OK:
The SVID master(Xeon) is driving the VDIO data on the pos edge of clock.

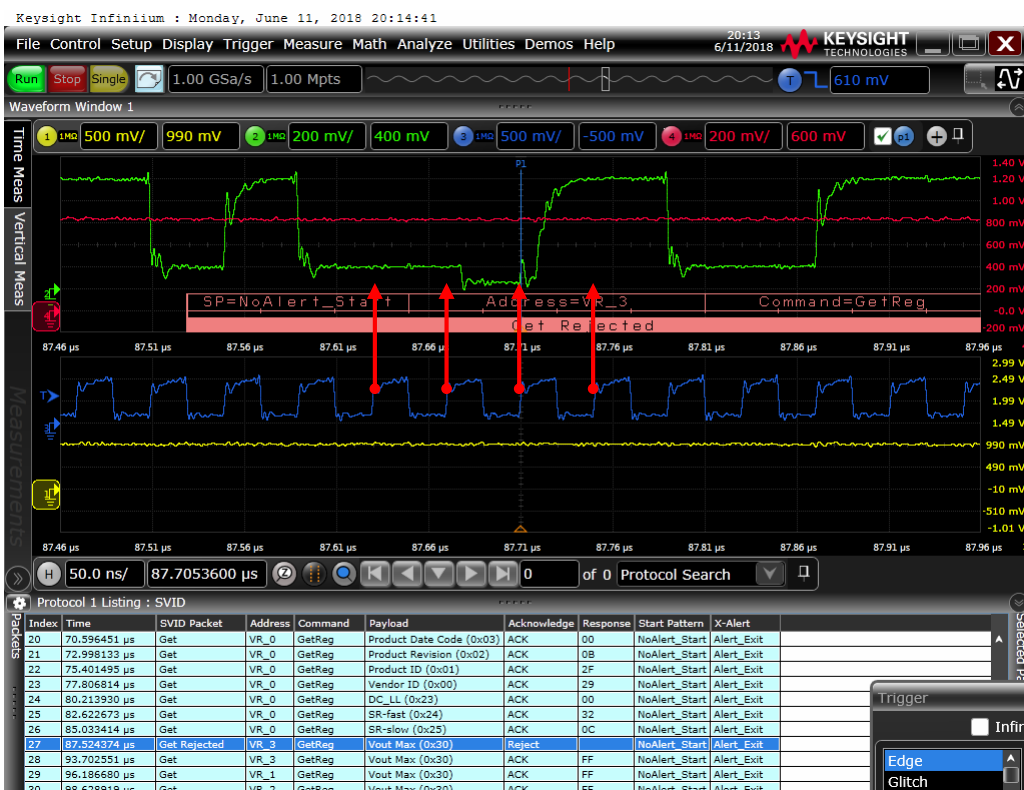
NG:
It seems that the VDIO edge is not matched with the pos clock edge, and the address field has two low-voltage-level.
It might be collision between the SVID master output and the phantom pulse.
If so, there is a possibility that the SVID transaction will be unintended garbled data. (the address data will be garbled, and so on.)
